1103 SUMMIT AVE

RECOMMENDATION
06/27/2018 #3028322

EARLY DESIGN GUIDANCE RESPONSES

EDG STREETSCAPE ALONG SPRING ST

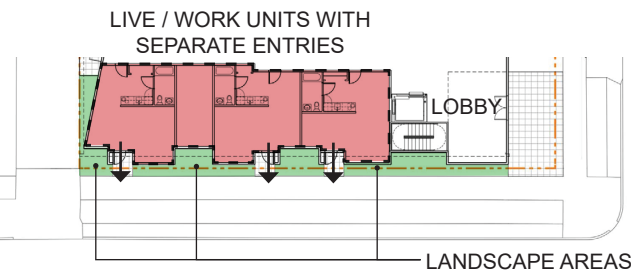
The Board stated that any of the proposed building options would be compatible with the neighborhood: However, the Board was least supportive of Option C, as it was the least interesting in terms of its overall design elements. The Board noted that the materials chosen for all three options did not demonstrate how these options are the best design approach or response to neighborhood context. The Board advised developing a contemporary approach or response to neighborhood context. The proposed articulation should also be modified to respond to the neighborhood context.

- a) The board gave guidance to develop the design with additional building fenestration, detailing and a different choice in materials.
- b) In agreement with public comment about using a mid block entry, the board requested a study of entry options and nearby context.
- c) The board requested further review and consideration of landscaping and sidewalk treatments that respond to existing neighborhood patterns.

The design team has moved forward with the massing of option A, while adapting the Board’s guidance to revise the building materials to primarily brick and glazing along the street facing facades, with a unique metal panel system as a tertiary material. The ground floor has been revised to remove the earlier proposed live/work units, in favor of a continuous verdant landscape buffer along Spring Street. Modulation and visual interest is provided by the brick pilasters and careful detailing, particularly at the lower floors, to achieve a streetscape that is highly textural, and pedestrian scaled. The “shifting bar” massing concept creates open space at the corner, which encourages interaction between the building and the neighborhood, while also forming a natural location for the residential entry and high-transparency, two-story lobby. Studies reinforcing a corner entry approach vs. a mid-block entry are provided on page 6.

PROPOSED STREETSCAPE ALONG SPRING STREET

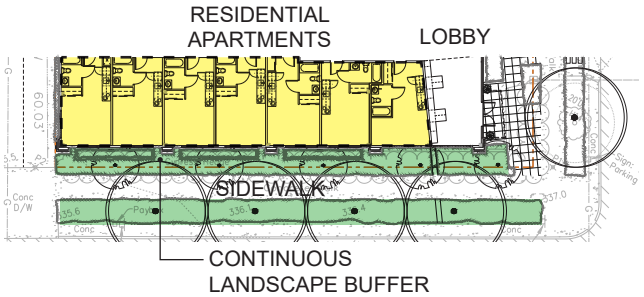
The Board requested additional information about the Live-Work units. The applicant should demonstrate whether these units will be designed to function as primarily residential apartments, or live-work.

The ground floor layout has been revised and the Live-Work units along Spring Street, as well as the individual entries, have been removed in favor of a continuous, abundant landscape buffer, per the Board’s guidance and recommendation. Modulation and visual interest is created by the rigorous brick expression of the south façade continuing to ground level, with additional detailing.

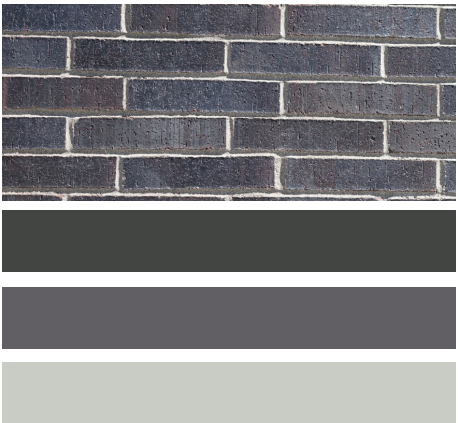
The Board agreed with the public sentiment that landscaping should be abundant, well designed and maintained, and reflecting the neighborhood character. The Board strongly encouraged the development of a landscaping plan in response to these items.

- a) The board requested clear and specific information about the type and location of landscaping elements, along with a maintenance and irrigation plan designed to make it a functioning landscape.
- b) The board strongly encouraged the applicant to provide larger caliper trees than the minimum required.

A rich, verdant landscape is proposed adjacent to the sidewalk and within the planting strip, with additional open space at both the main entry in the southwest corner and adjacent to the alley in the northwest corner. New street trees are proposed in the planting strip along both Spring Street and Summit Ave. A rendered landscape plan, character images, and pictures of proposed species of plants are provided on pages 24 & 25.

Street-facing facade

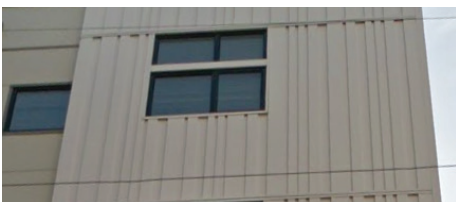
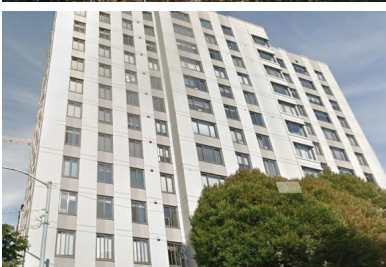
The board agreed that the use of fiber cement is not an appropriate response to context at this location, or for this scale of building. The Board noted that the use of high quality materials compatible with the neighborhood is reflected in the priority Design Guidelines. The Board also agreed that the use of metal siding as a primary material is out of character with the neighborhood, unless it is used in small areas.

- a) The Board asked the applicant to continue their investigation of their fenestration patterns and demonstrate how the proposed relates to the neighborhood context.
- b) The Board requested that the applicant provide a couple of diagrams of different buildings with in a couple block radius, as suggested by the community during public comment. The proposed fenestration design for this building should be responsive to context, not driven by unit sizes.
- c) At the Recommendation meeting, the applicant should demonstrate how the fenestration detailing takes into account the location of vents and incorporates high quality materials that reflect the neighborhood character.

A material palette of brick, glass, and infill metal panel are proposed for the street facing facades, compatible with the high-quality materials found on other First Hill buildings. The fenestration patterns have been revised to live within a rigorous masonry frame expression which is consistent along the full height and length of the south bar. The same material palette and fenestration patterns are carried across the street facing facades of the North bar and a large section of the alley elevation. The masonry frame steps down to create a massing transition from the taller buildings to the south to the shorter adjacent structures to the north and west. The upper floor and north façade of the north bar are clad in a light colored, durable commercial-grade fiber cement system (Hardie Reveal 2.0), contrasting the substantial masonry base. The fenestration on the north facing façade is smaller in scale, minimizing the impact to the adjacent residential building. Additional analysis and information regarding materiality is provided on page 7

A brick frame clads the street facing facade, with the rest of the color palette consisting of compatible neutral colors. A dynamic metal panel system consisting of varying width vertical panels adds shade, shadow, and relief and detailing for the infill on the street facing facades.

The fenestration patterns of the building are driven by the materiality (residing within the brick frame) on the street facing facades. Smaller, vertically stacked “punched” windows that reflect the pattern and scale of fenestration on nearby buildings are present on the north and west facade, where adjacent to other residential buildings.

PROPOSED DESIGN, MASONRY FRAME REPLACES PROJECTING BALCONIES

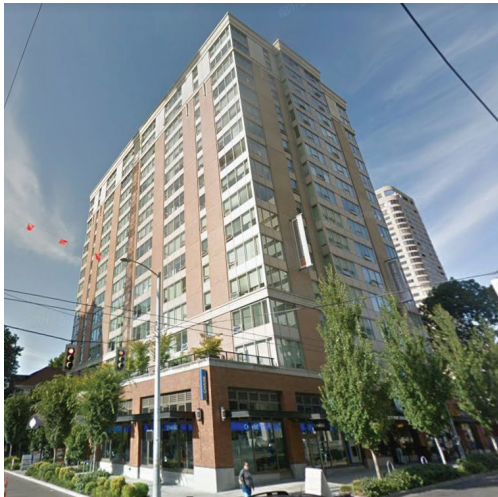
The Board agreed with the public comment that the balconies are too small to be usable and may only be used for storage. The Board gave guidance to redesign the balconies to either be Juliet balconies or larger balconies that can be used for a table and two chairs.

The small balconies on the south façade presented at the Early Design Guidance meeting have been removed in favor of a rigorous masonry frame expression. The landscaped entry courtyard and a large common amenity roof deck provide outdoor space for the residents.

Projecting Balconies, removed per board guidance

Masonry frame expression envelops the south volume, adding shade, shadow, and relief

Additional detailing of the brick at the lower levels create further visual interest at street level.
